McCULLOCH SERVICE BULLETIN

NO. 1619

MODEL All Current Generators

SUBJECT Addition of Washers, P/N 21655

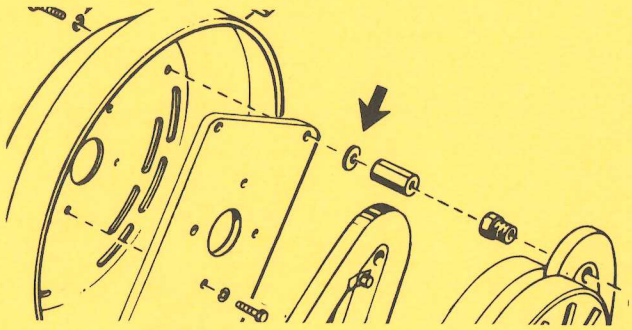
To provide better thread engagement of the stator adjusting screws, a standard 5/16 inch, flat Washer, P/N 21655, is now being placed between each stator post and the stator support plate.

Units with serial numbers larger than the ones listed above will contain four Washers, P/N 21655. Also, all H-1500F, H-2000F, and H-3000G models will be produced with the washers.

It is not necessary to rework earlier models produced without the washers. However, if increased thread engagement of the stator adjusting screws is desired, the washers can be installed on earlier models at the time other routine service is being performed.
